PRP Comments
16.06.23
Drawing Review 02

Note: These comments are solely in the capacity of Passivhaus Designer, with no design responsibility.

Ashley Road Depot

Roof Details - SMJ Flat Roof

Precast balcony edge component fixed back to projecting balcony structure to Specialist Subcontractor design and details

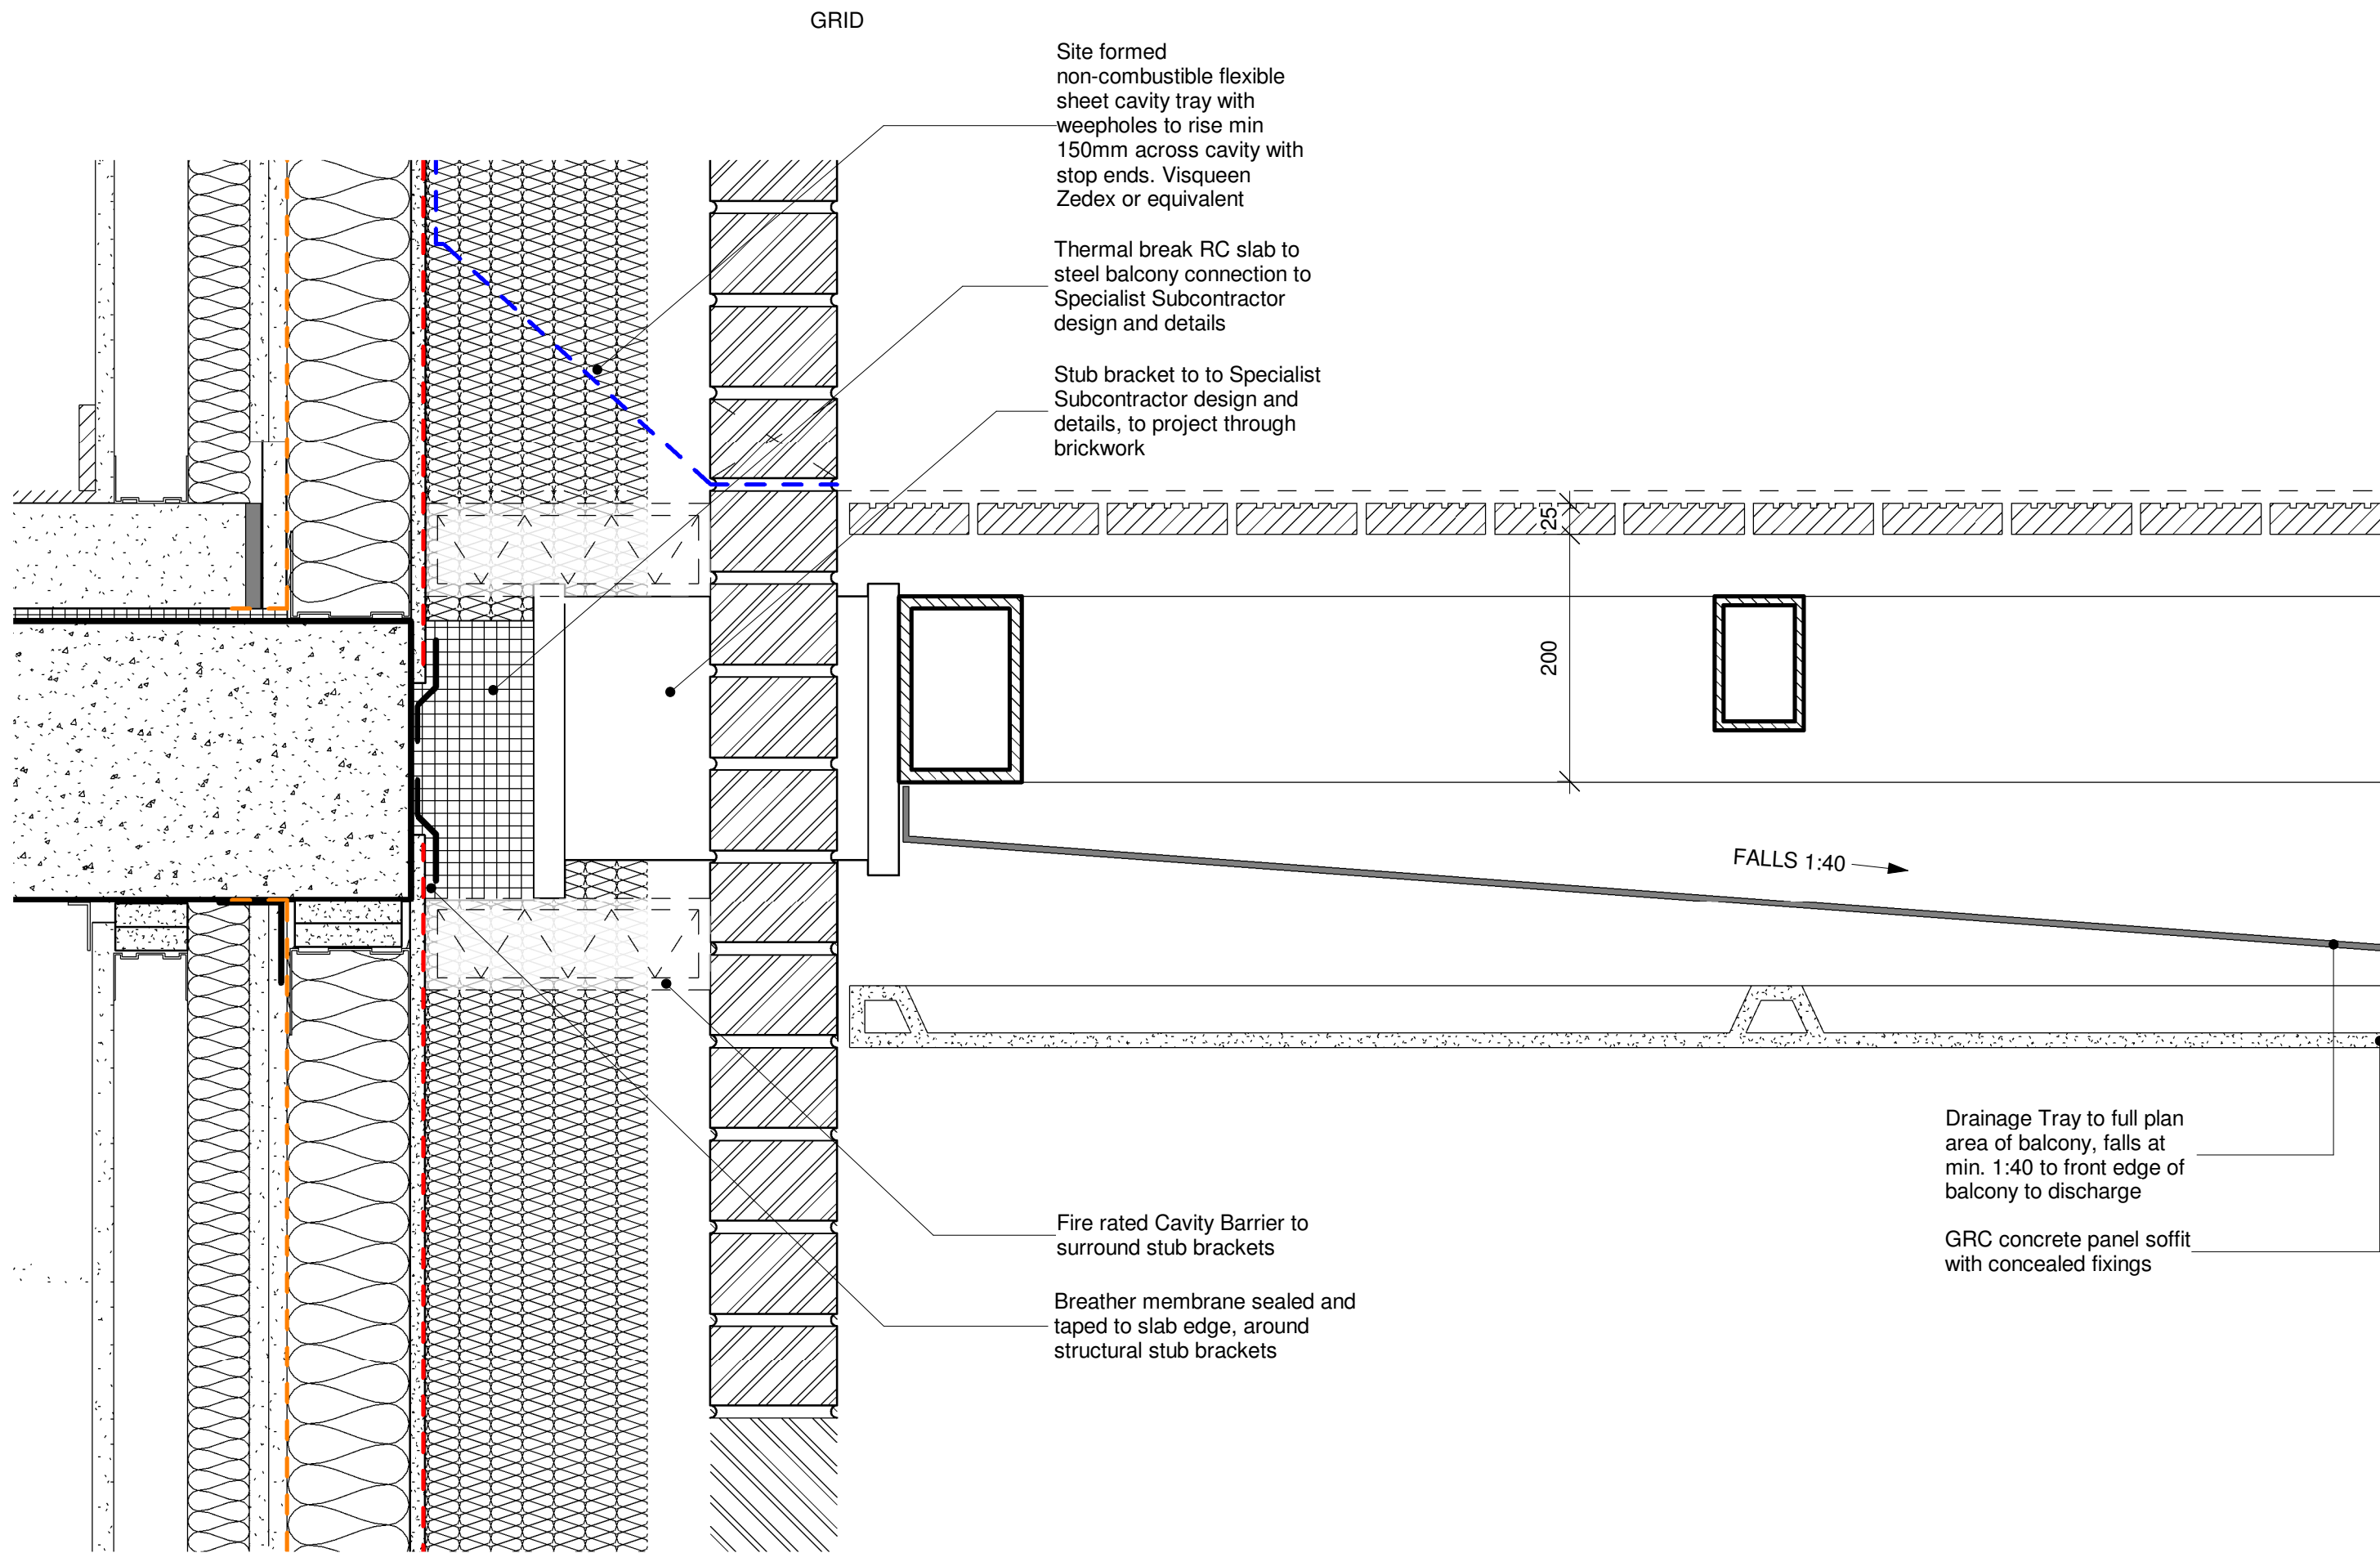
Windows: These should not be greater than **0.8 W/(m²K)**. This is what you have referenced below, so this is a comfortable position to be in. Windows should also have an insulated frame, be triple glazed, sit within the thermal envelope line and not break the airtightness line. A Ug-value should be 0.5 W/(m²K).

Dwelling access doors from outside: If these contain glass, the u-value must be **0.8 W/(m²K)**. External doors (without glazing) must not have a greater u-value than **1.0 W/(m²K)**. There should be no letterboxes in the doors. Doors should be insulated with airtightness properties, aligning with the wall's thermal envelope line and not break the airtightness line.

Curtain walling screens: These should not be greater than **0.8 W/(m²K)**.

Doors within curtain walling if different to the screens themselves: These should not be greater than **0.8 W/(m²K)**.

Ancillary doors to heated and unheated spaces: This is under review regarding the lift core, stair core and circulation spaces. Doors within the dwellings and overall thermal envelope do not necessarily need to achieve a specific u-value, however, to align with MVHR (Mechanical Ventilation Heat Recovery) and ventilation systems a 10mm undercut is required beneath internal doors of dwellings. Doors into unheated spaces will require to meet the same as an external door, if they sit within the thermal envelope line, they would be treated with the same thermal properties and airtightness requirements as an external door. The exact approach for this within Ashley Road differs across the three blocks/phases and is still under review.

2 | Party Wall (Shear Wall PW-10) at Intermediate Floor
1 : 5

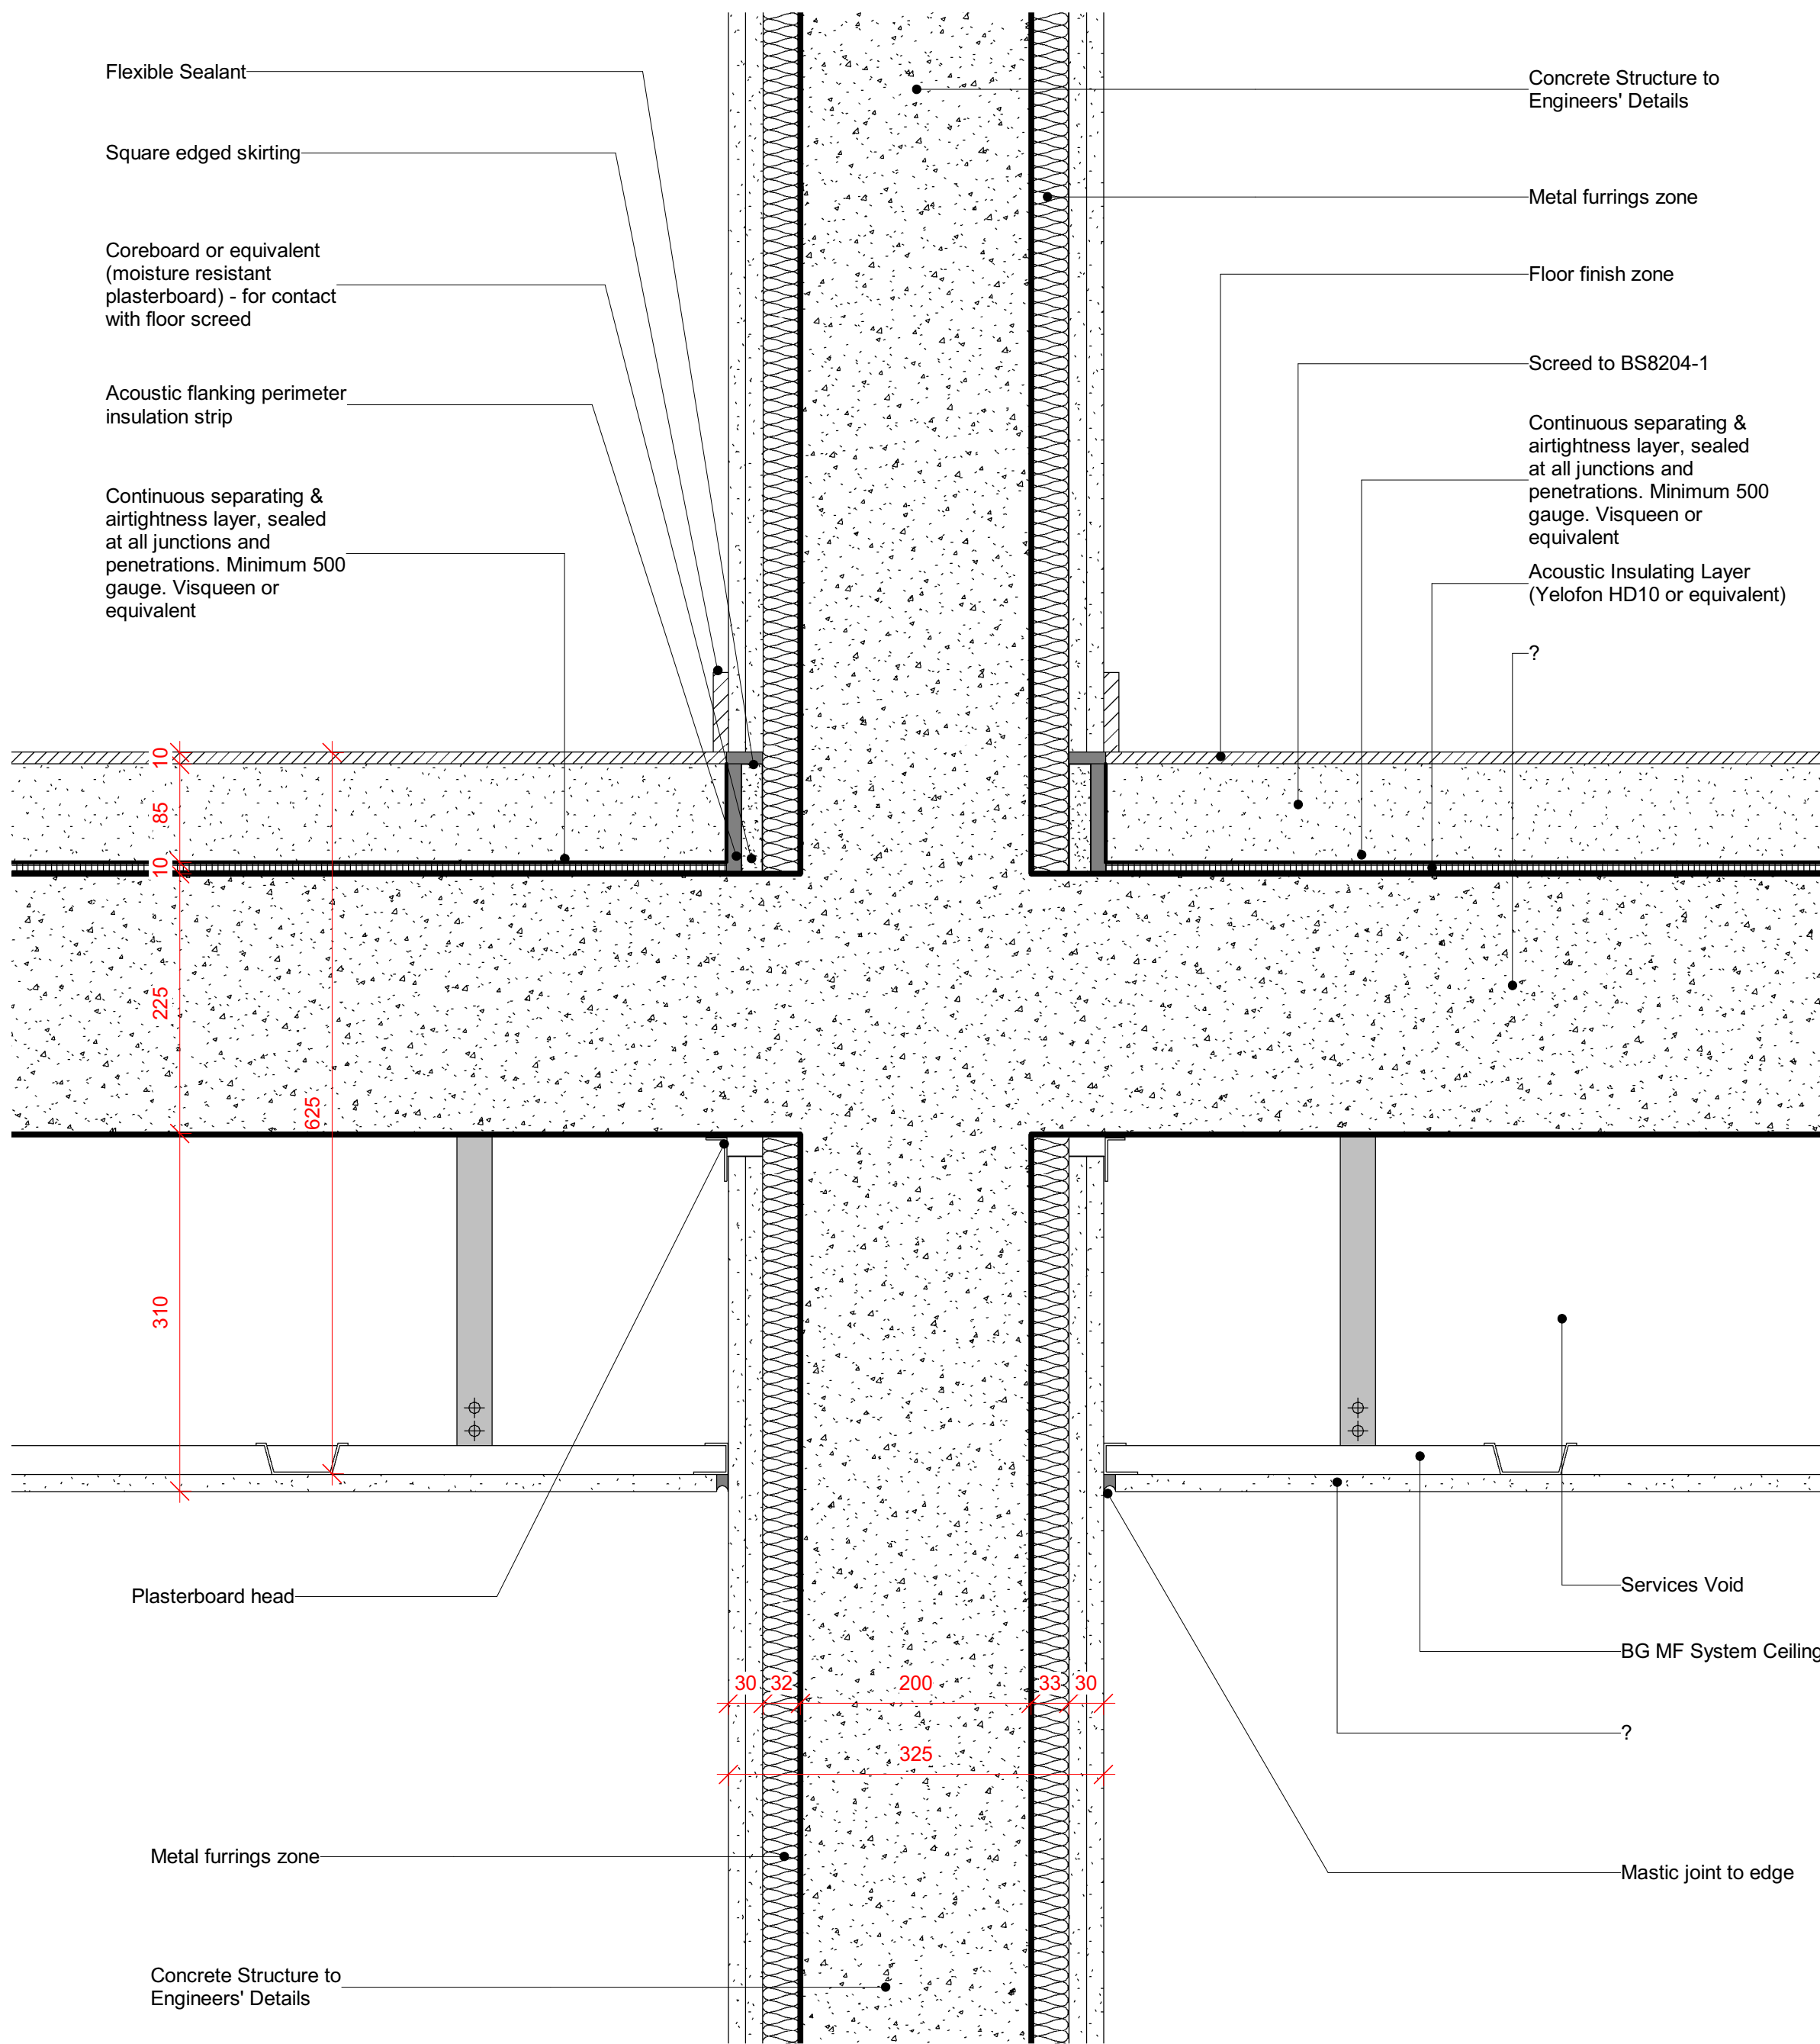
See Psi value calculations in drawing review pack.
